# **1029 Burdette**

Submittal for Design Review  
University Area Design Overlay

I would like to introduce myself as the planner assigned to your design review request, **DR040-25**. For staff to continue processing your request, please address the following regarding **DR040-25** below:

## Precedents of Similar Form

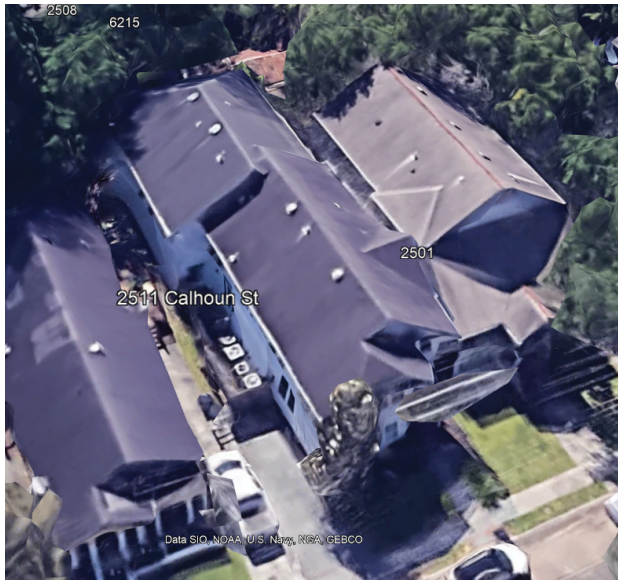
**2. Clarification:** Please provide precedents that reference the proposed form.

Please see the attached pdf, showing precedents of similar form across uptown.

A202

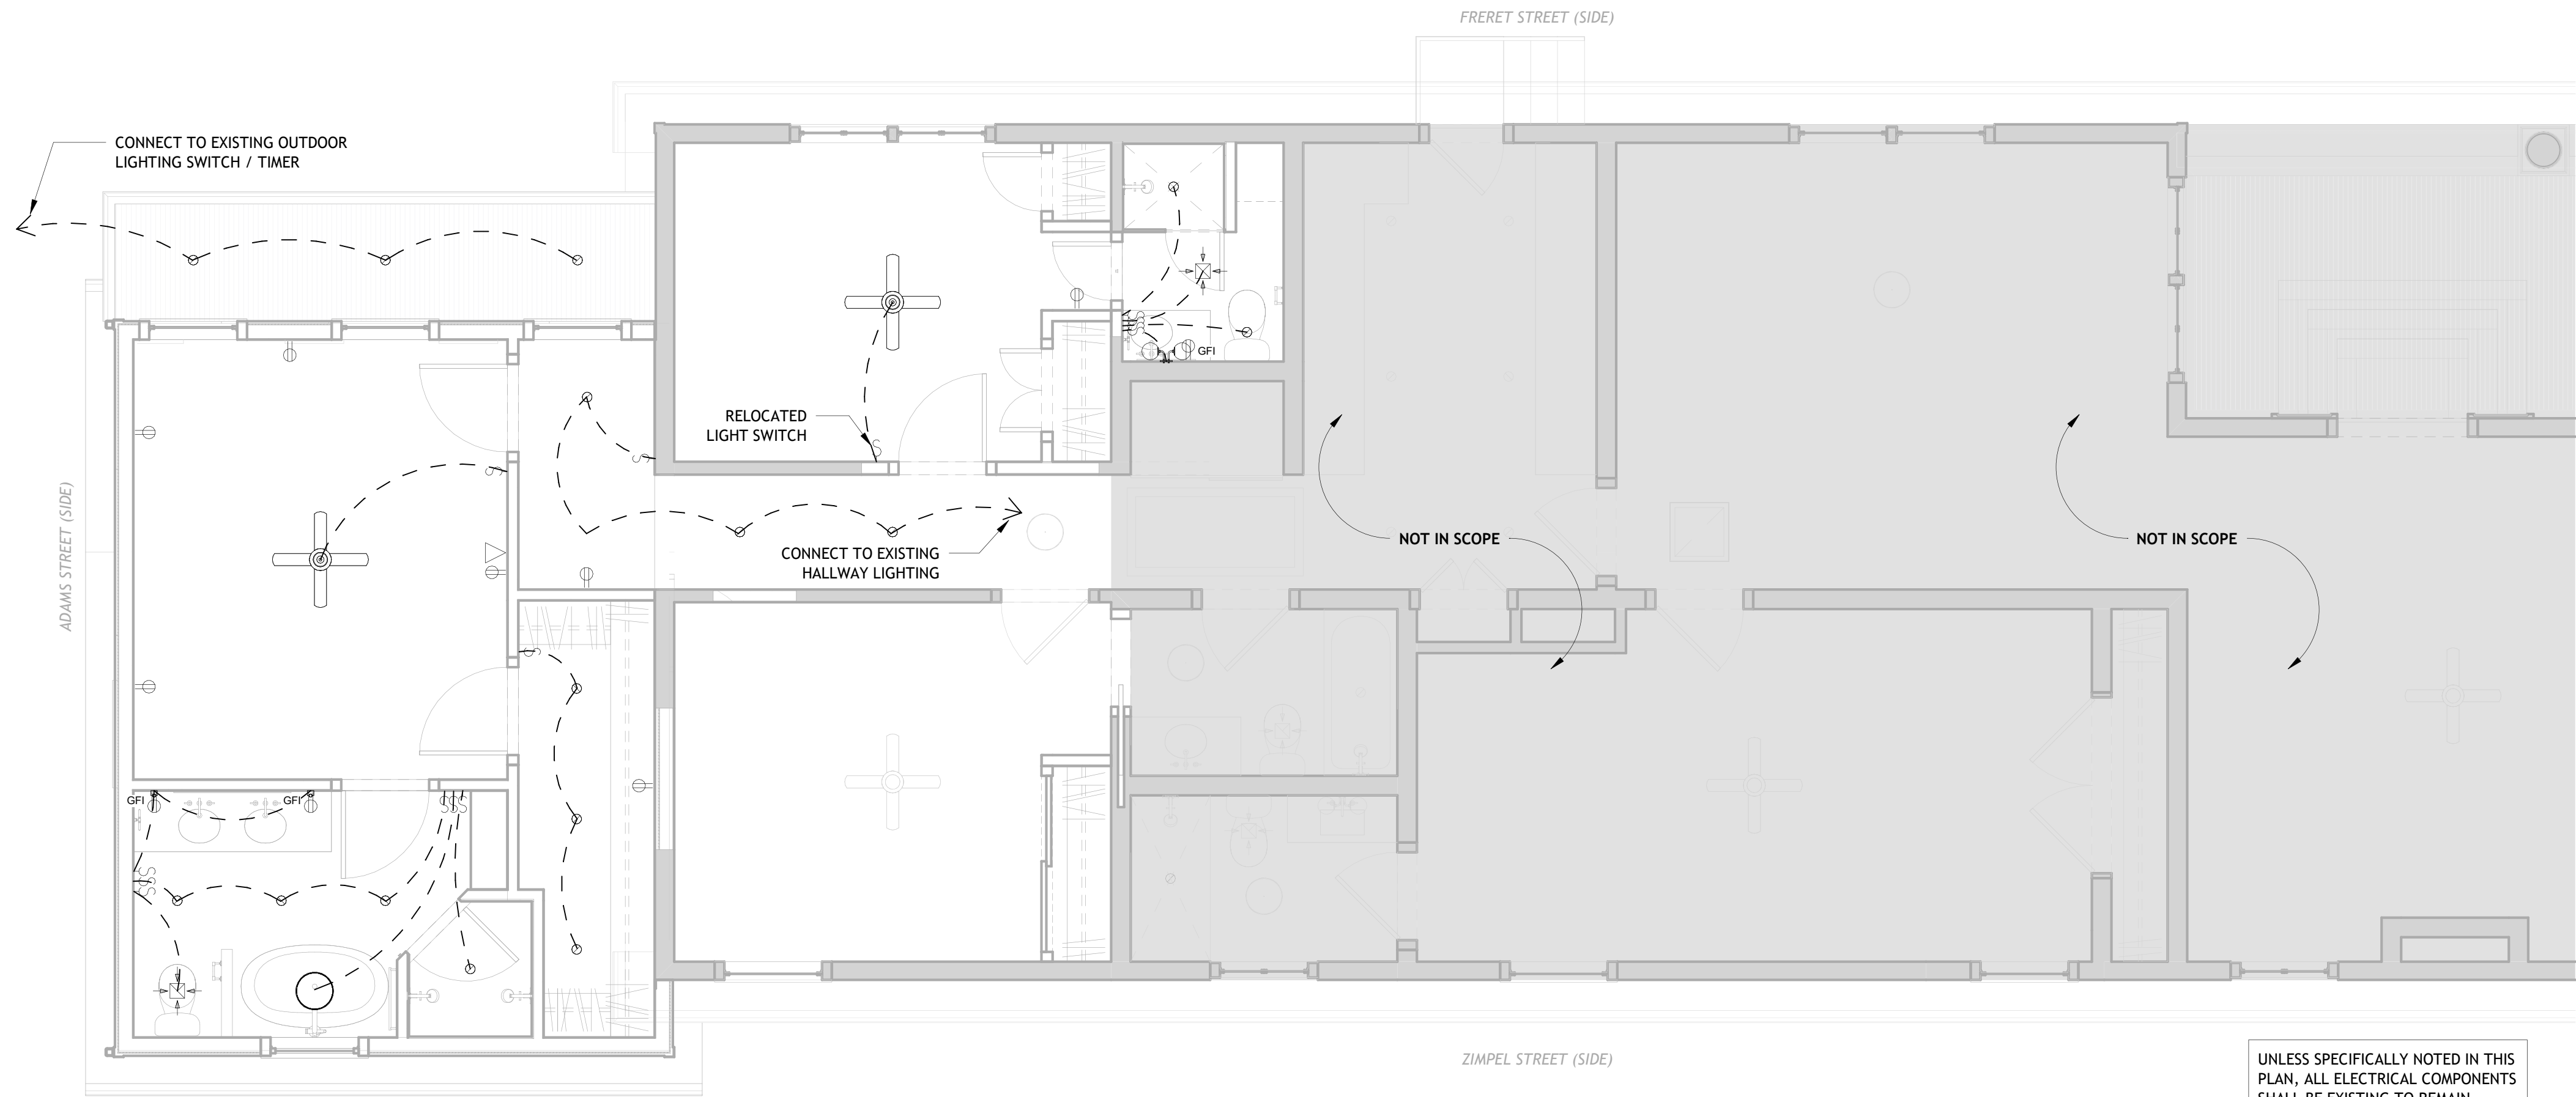
**1. Clarification:** Please explain the design intent of proposed roof line.

The proposed roofline and form is intended to achieve the client's goals with minimum visual impact from the public right-of-way - the drivers are outlined below:

1) Usable yard space.

By building to the allowable side and rear yards, we are able to limit the buildable edge encroachment toward the south side (driveway side) of the property. This creates the most usable backyard for the Owners and their children.

2) Desired ceiling height.

At the first meeting, the Owner's expressed they wanted to achieve close to a 12' ceiling height in the addition, which is a relatively standard ceiling height found in similar residences throughout New Orleans.

3) Usable attic storage space.

As a family with growing children, usable storage is always at the forefront of many Owner's minds. By moving the roof line up, we are maintaining the vertical relationship between the attic joists and ridge beam of the original house, and are not sacrificing usable attic storage space.

4) Cost.

We have discussed the cost of offsetting the roof and tying into the existing roof with the Contractor. It was stated that offsetting the roof would provide some cost savings for the project.

5) Nailing patterns.

Additionally, we have had recent projects where the nailing strips on the new shingles do not match the old nailing strips (even though the colors match), resulting in an undesirable look at the intersection of the two. By separating the roofs, we will be able to achieve a cleaner change in shingle pattern at the addition without having to replace the entire existing roof as well.

The overall roofline follows the slope and character of the existing roofline. The vertical projection is minimal, making it difficult to see from the public right-of-way. Additionally, by justifying the mass to the north side of the property it is moved further away from the existing driveway, making the addition even less visible from the public right-of-way.
